Preamp Power Supply  
 Output Connector Support

SCALE	FILMED	DRAWING NUMBER	REV.
1:1		3823.121.MB-330282	A

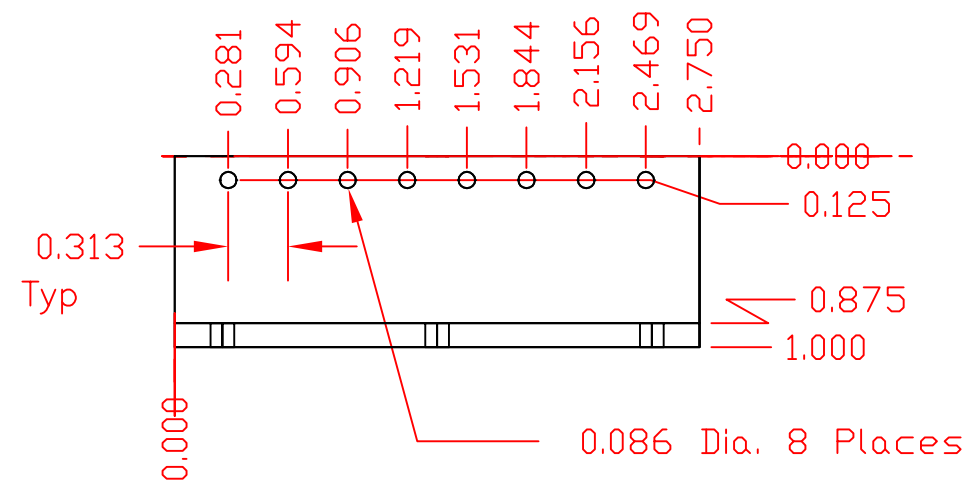
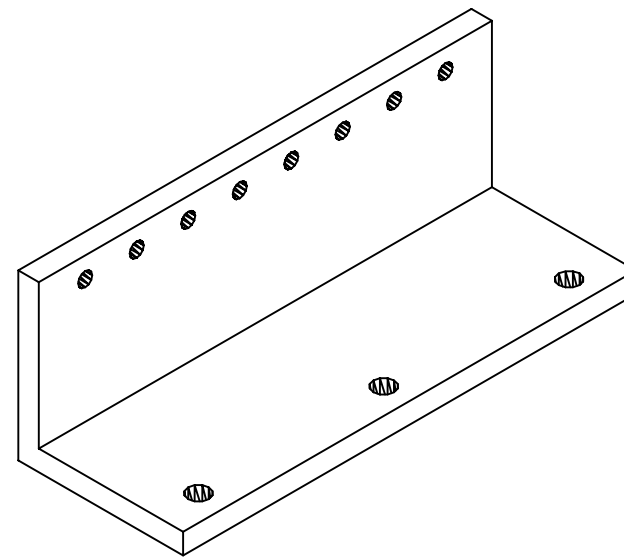
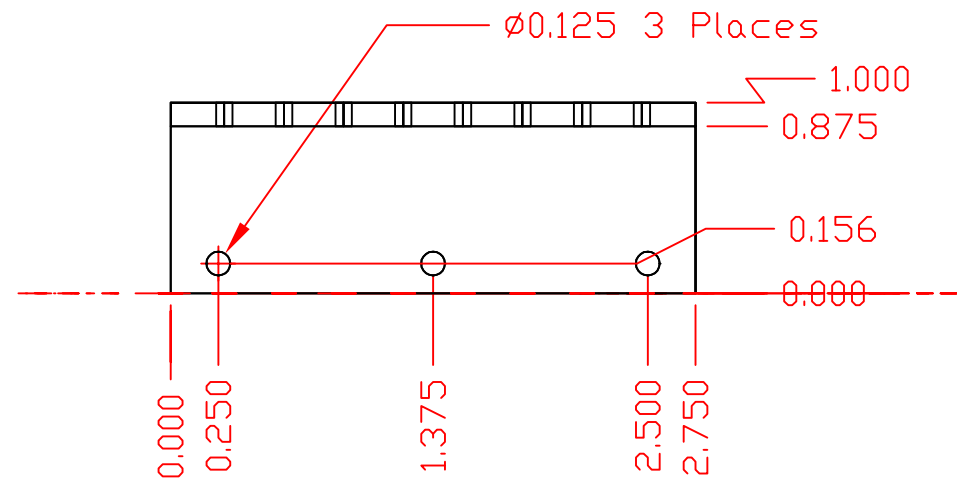
REV.	DESCRIPTION	DRAWN	DATE
		APPD.	DATE
A	Changed 7 to 8 Holes		6/8/99
